ADVISORY  
 BULLETIN

No. 99-6

## End Cap OptiMax Air Compressor

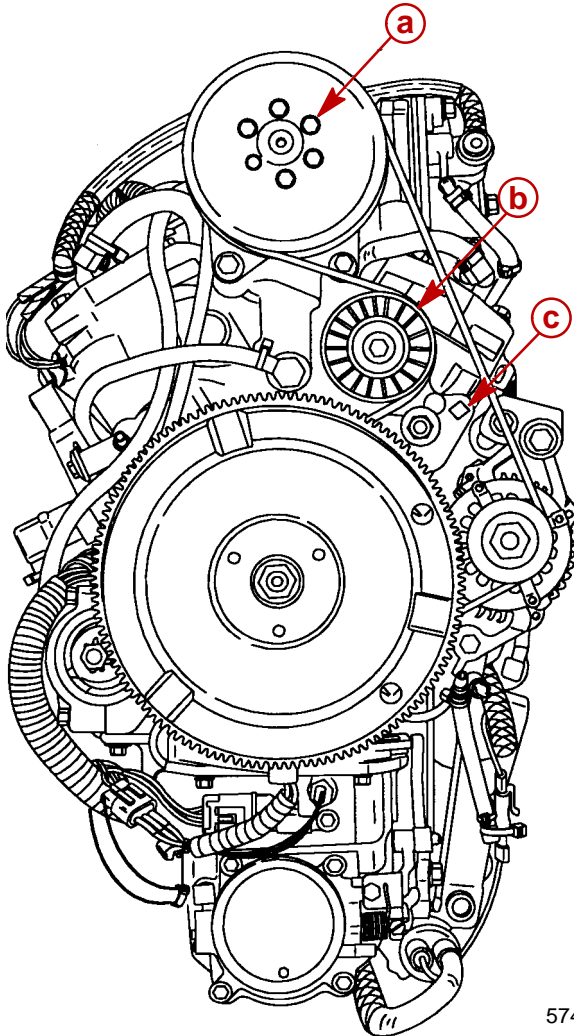
Return all compressor end cap assemblies **P/N 1173-828131A4** to Mercury Marine for credit.

Replace the air compressor end cap assembly with **P/N 1173-828131A5**. The new assembly includes the end cap, crankshaft, bearings, pulley flange, seals, and O-rings.

### 2.5 Liter

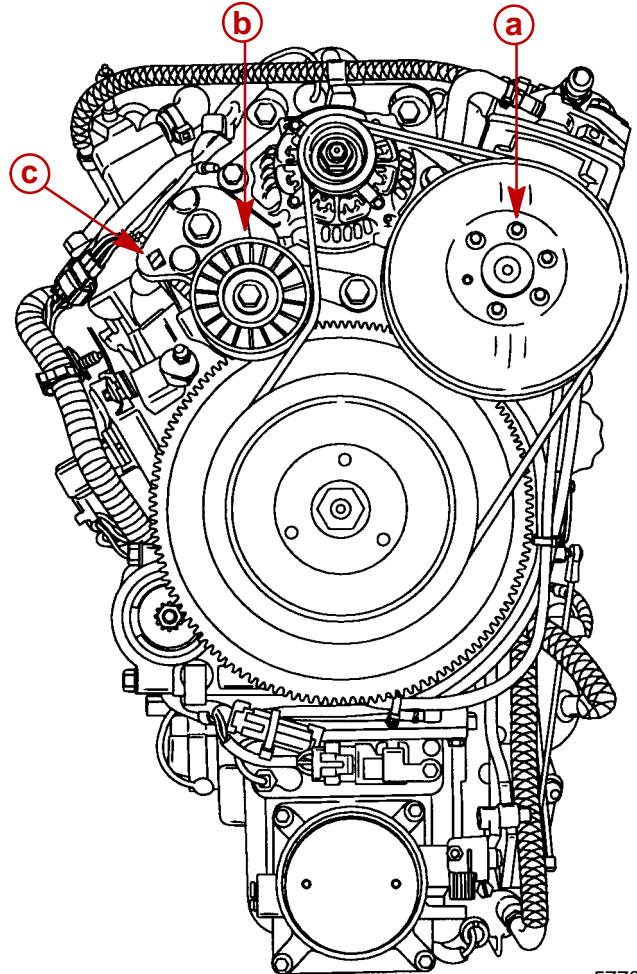
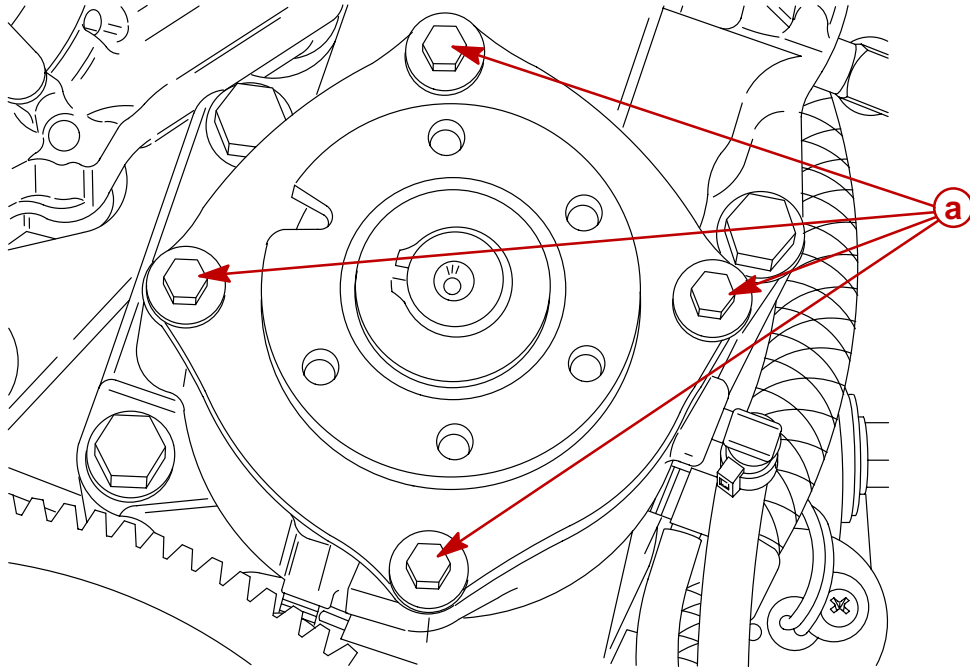
- Remove flywheel cover
- Use 3/8-inch (9.5 mm) drive on belt tensioner arm to relieve belt tension, and remove belt.
- Remove the 5 bolts that retain the pulley to the pulley flange.

- a** - Pulley retaining bolts (5)
- b** - Tensioner
- c** - 3/8 (9.5 mm) square drive

**a** - End cap retaining bolts (4)

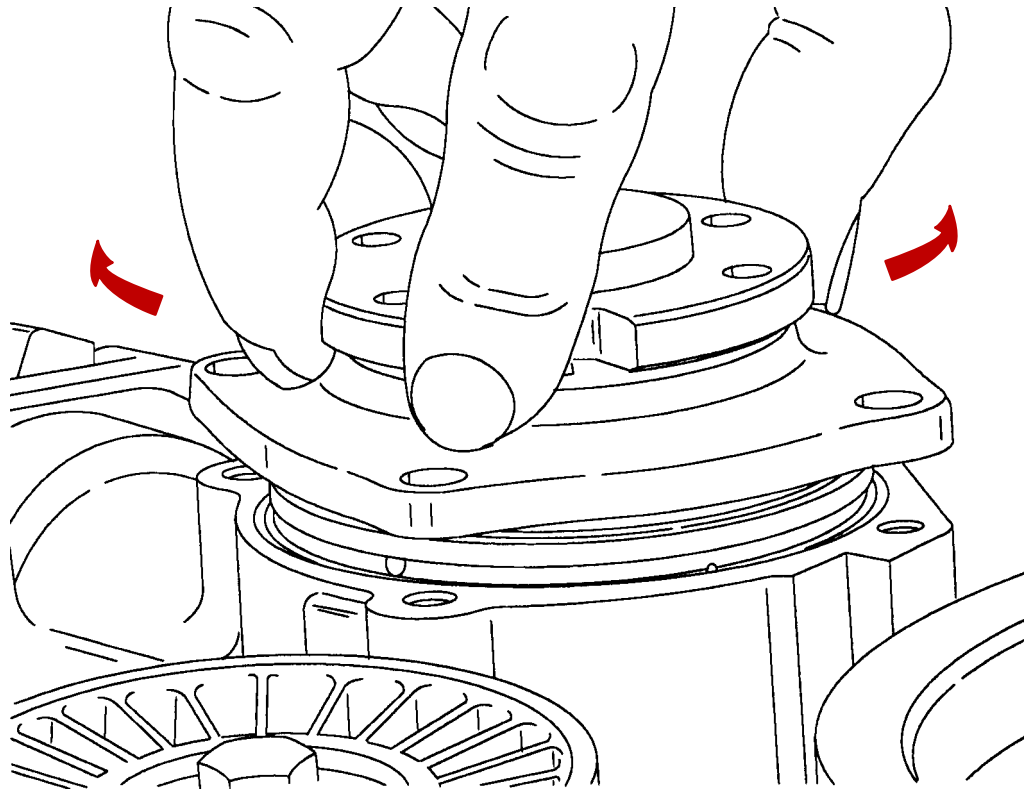
- Remove the 4 bolts that retain the end cap to the compressor body.

- While rotating the pulley flange alternately clockwise and counterclockwise about 1/8 to 1/4 turn, pull outward on the pulley flange. Continue rotating until the end cap assembly has been removed from the compressor body.

## Reassembly

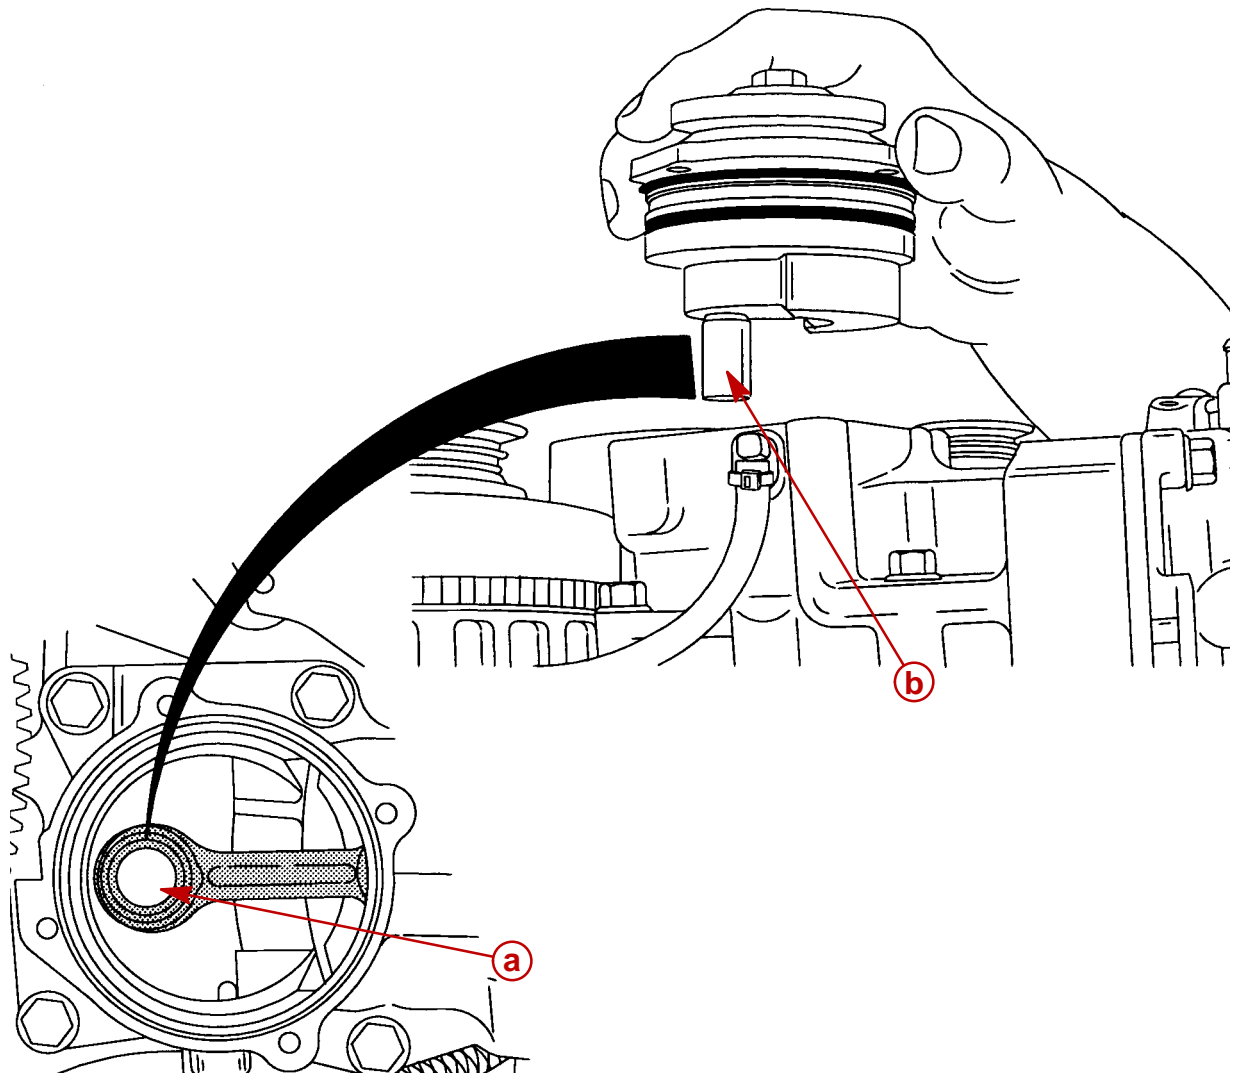
- Lubricate end cap O-ring and O-ring contact area in compressor body with two cycle oil.
- Slide the new end cap assembly into the compressor body, keeping the connecting rod journal lined up with the open end of the connecting rod, until the crankshaft just enters the open end of the connecting rod.

- a** - Connecting rod open end
- b** - Crankshaft connecting rod Journal

- While rotating the pulley flange clockwise and counterclockwise, push the end cap into the compressor. Continue rotating the flange until the end cap is all the way down against the compressor body.
- To confirm that the connecting rod journal has properly engaged with the connecting rod, rotate the flange until you feel resistance from the piston trying to compress air in the cylinder.
- Apply Loctite 271 (P/N 92-809820) to the threads of the end cap retaining bolts and torque to 100 lb. in. (11.5 Nm).
- Apply Loctite 271 (P/N 92-809820) to the pulley retaining bolts and torque to 100 lb. in. (11.5 Nm).
- Install compressor/alternator belt.
- Run engine to confirm that compressor is functioning correctly.
